CASE FILE NUMBER: LU 09-105857 AD

NOTICE OF A REVISED TYPE II DECISION ON A PROPOSAL IN YOUR NEIGHBORHOOD

The purpose of this revised decision is to analyze the impact, if any, of proposed changes to the north and west facades of the garage/Accessory Dwelling Unit structure that were approved earlier this year. Details follow in bold.

*Exhibit C, D
 Revised Site Plan*

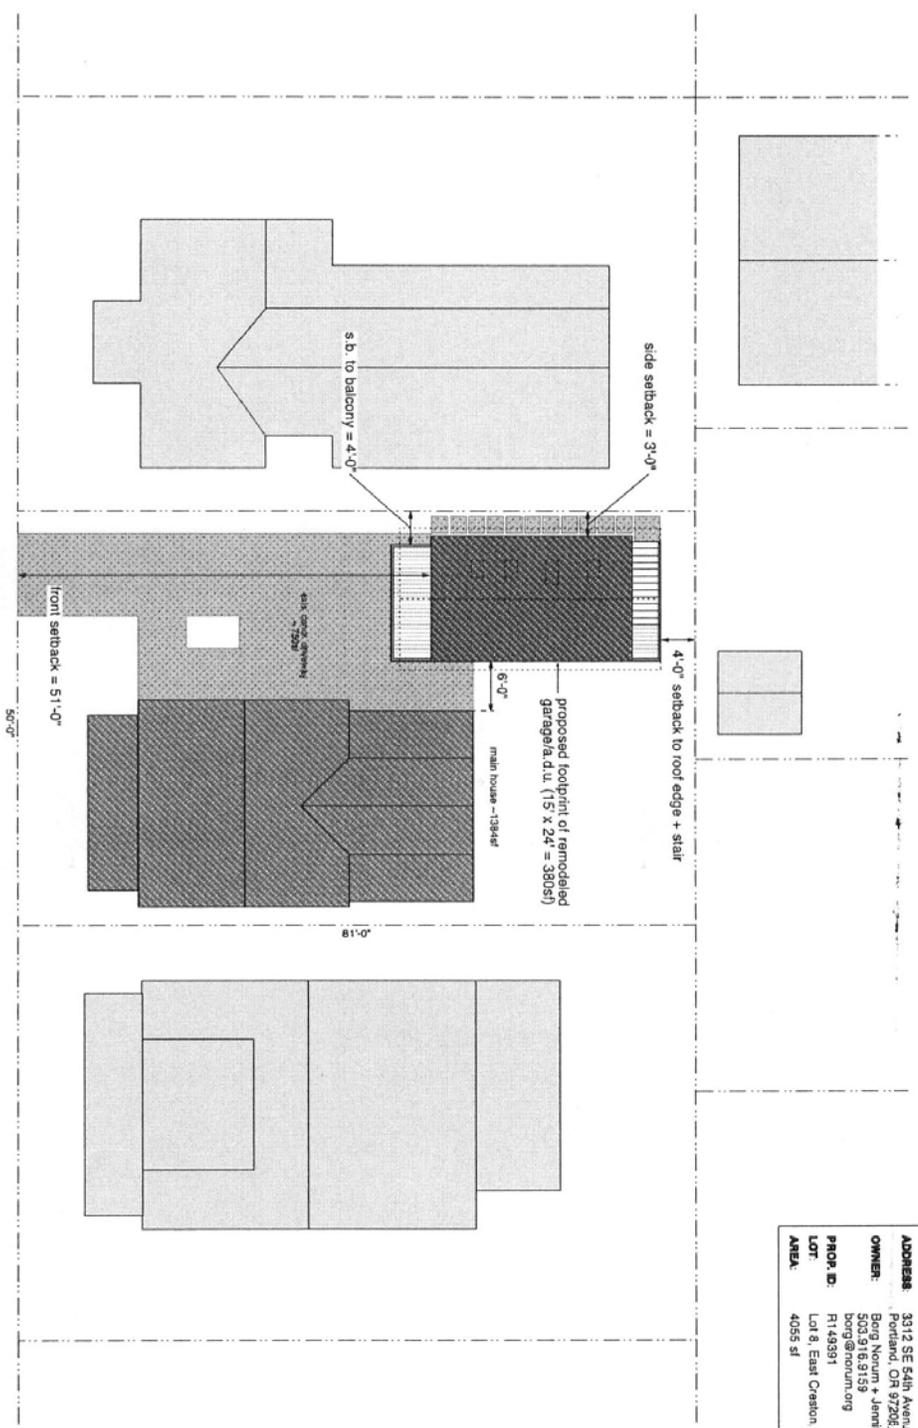
The applicant is proposing to locate a new, 2-story, 16' x 24' structure in the northeast corner of the lot. The proposed structure contains a garage/studio on the first floor and an accessory dwelling unit (ADU) on the second floor. The proposed garage/ADU is located 3 feet from the north side property line, and the associated eave is located 2 feet from the north side property line. **Per revised elevations drawings, a 20-inch by 32-inch bathroom window will be located approximately 12 feet above grade on the north façade. The west wall of the structure will be located 51 feet from the front property line, as approved in March 2009. Revisions to the plans now show a balcony that will extend 5 feet from the west façade. This will not trigger a new adjustment because balconies may extend into a required setback (the approved 51 feet) up to 20%.**

1. To zoning code section **33.110.220, Setbacks, and Table 110-3**, in order to locate the proposed new, 2-story, 18-foot high garage/ADU structure 3 feet from the north side property line with the associated eave located 2 feet from the north side property line; and
2. To zoning code section **33.205.030.D.1, ADU Setbacks**, to allow the front wall of the ADU to be located 51 feet from the front lot line, **with a 5-foot wide balcony at 46 feet from the front lot line**;

Exhibit C.7
 Revised west and north elevations

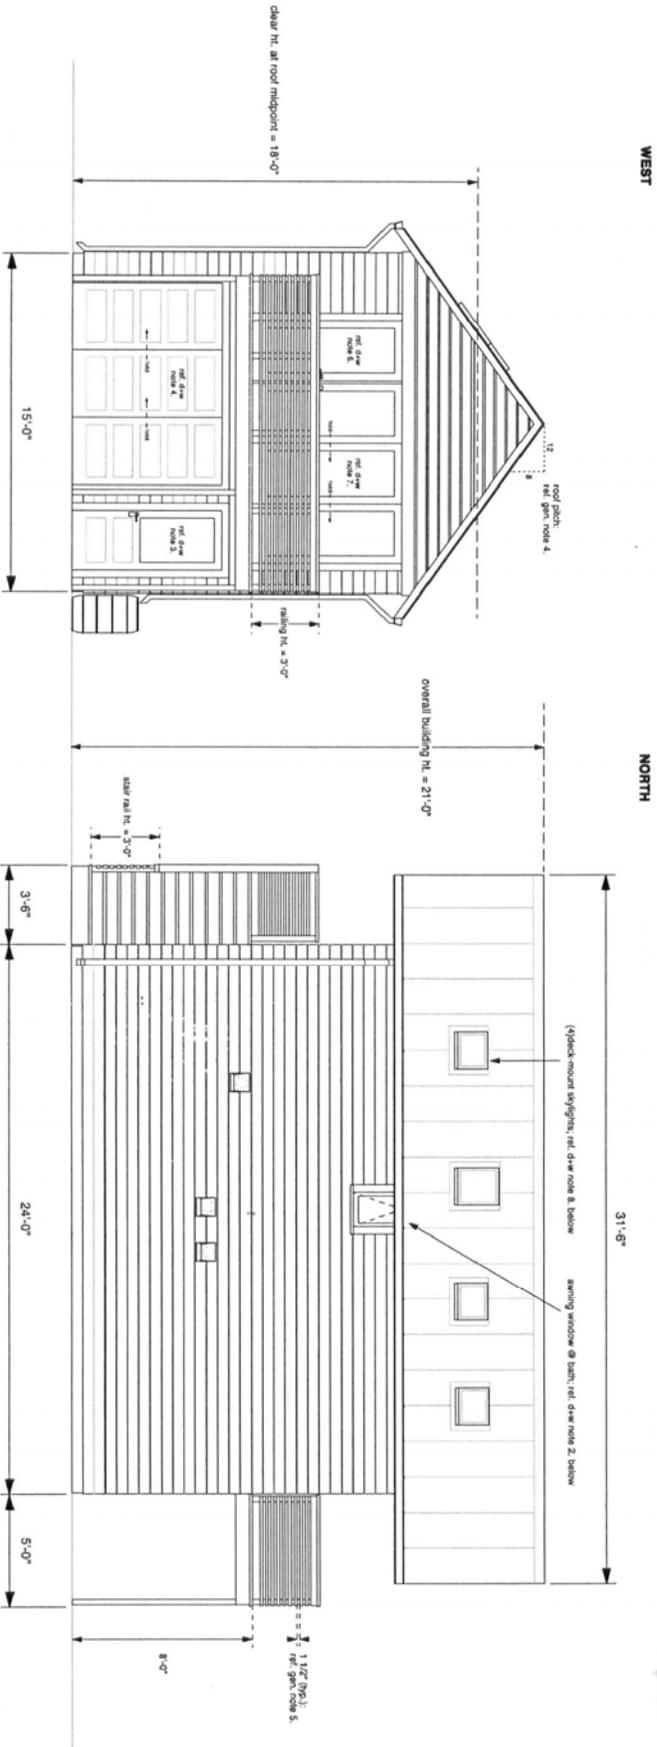
One change of note is a 20-inch by 32-inch second-floor window on the north side to provide light and ventilation to the ADU bathroom. The approved elevation had indicated no openings on that façade. Another change of note is to replace the pair of second-floor double-hung windows indicated in the original design on the west façade, with a single swing door plus 3-panel folding door assembly opening onto a balcony. The 5-foot wide balcony moves the structure closer to the front property line, but such balconies or decks are allowed to encroach into a required setback (in this case the approved 51 feet) by up to 20%. Neither the proposed window on the north façade or the proposed balcony on the west façade trigger a new adjustment. But, because the approved adjustments were for development related to the north and west facades, new findings must be made to document that the proposed changes to these facades are in compliance with the approval criteria.

The north elevation, which faces a residential structure, **will contain one small bathroom window of "obscured" glass set high in the wall, with the sill located approximately 4.5- to 5-feet above the floor level. Such size, placement and materials will limit opportunities for views through the window, in either direction. Per a photo submitted by the applicant, the existing development and vegetation on the property to the north also will limit sightlines that could compromise the neighbors' privacy.** The front yard area for the ADU is concentrated on the south side of the site, in the existing outdoor area. **The addition of a balcony on the west façade, bringing the structure closer to the street, will not have any impact on privacy since it is 46 feet from the street and it complies with setback requirements to the north.** Therefore, options for privacy for neighboring properties are maintained.

Findings: The proposed ADU contains **only one small window placed high** on the north side and located away from the outdoor area of the adjacent lot to the north. Landscaping is located along the common property line, offering screening and softening of the north wall. There are no perceived impacts resulting from the request to allow a 3-foot side building setback. The proposed structure reflects the style of the existing home, and the design of the street-facing façade minimizes the appearance of the ADU in relation to the garage and primary home. There are no perceived impacts resulting from the request to locate the **west building wall of the ADU 51 feet from the front property line nor from the addition of a 5-foot wide, second level balcony on that west wall that brings the structure to within 46 feet of the front property line.**
